NEW SUNROOFS

Beginning October 1, 2011, the Hollandia 600 and 700 series sunroofs will change. These sunroofs have several key upgrades that will be introduced. We have included some information for you to post in your facility to help communicate the changes to your colleagues.

--- Changes to Hollandia 600 and 700 inbuilt sunroofs. ---

Front and rear view of motor cover

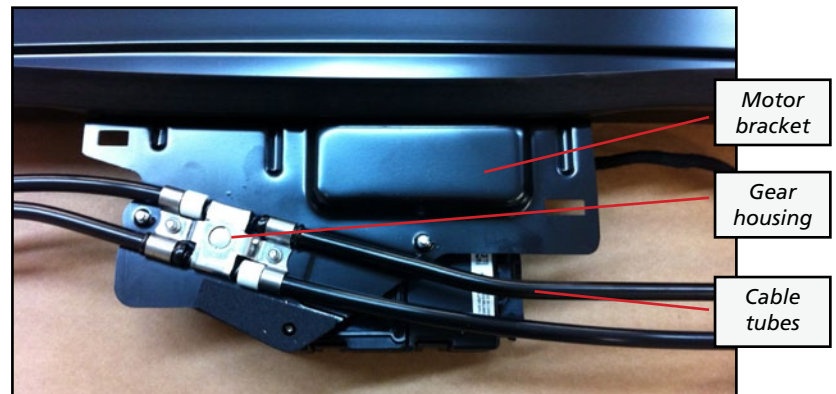
New Motor Cover

The H700-II motor cover has changed to accommodate the new motor/controller assembly. This cover "snaps" into place.

Cables and Cable Tubes

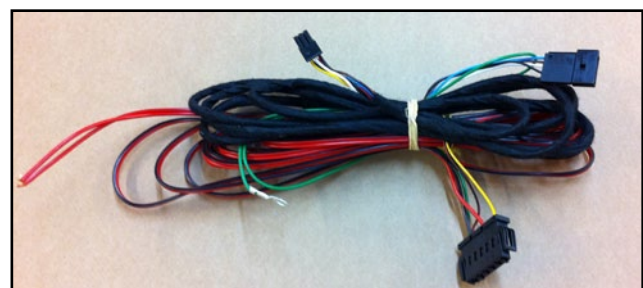
The drive cables and cable tubes are new.

Wire harness

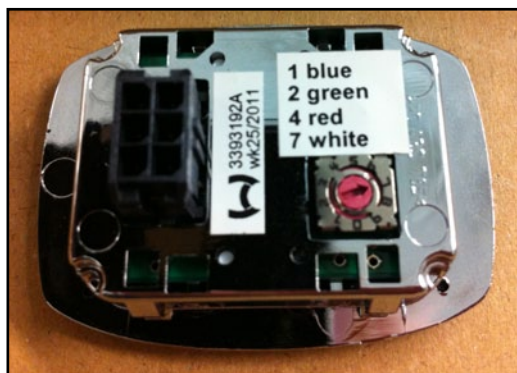
New Wire Harness

The new wire harness includes the connector for the new motor/controller assembly.

(H700-II Comfort, black, shown, part # 3393192A)

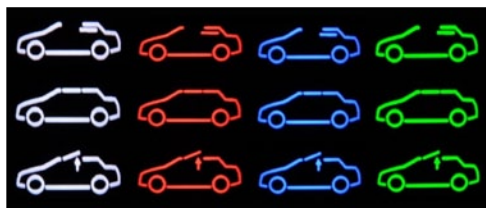
Switch and Sunshade Handle for the Comfort versions are shipped in a separate box.

The switch and sunshade handle for the Entry versions ships in the sunroof box.

Backlight LED color is set via selector switch on back of H700-II Comfort Switch.
Main choices are white (default), red, blue, and green.
